# 802.3dj D2.3

## Comment Resolution

## Electrical Track

### Reference transmitter does not meet SNDR requirements

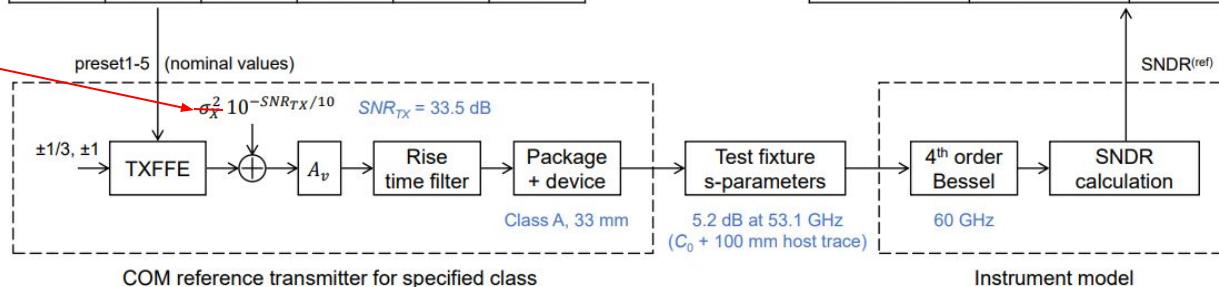
## Comment #39 continued

Error in slide

Addition of a factor of  $\sigma_X^2$  to the transmitter output noise model would make it inconsistent with the definition of SNDR.

The consequence would be that transmitter model used to compute Channel Operating Margin (COM) would not be consistent with transmitters that comply with the specification.

For the specification to be consistent, the  $\sigma_X^2$  term would need to be added to the definition of SNDR, the SNDR limits would need to be adjusted accordingly, and the COM  $SNR_{TX}$  value may also need to be reconsidered.

Editors' recommendation:

Reject.

The draft is self-consistent as it is written.

The proposed change would introduce an inconsistency between the noise model and the definition of the impairment it is intended to represent.
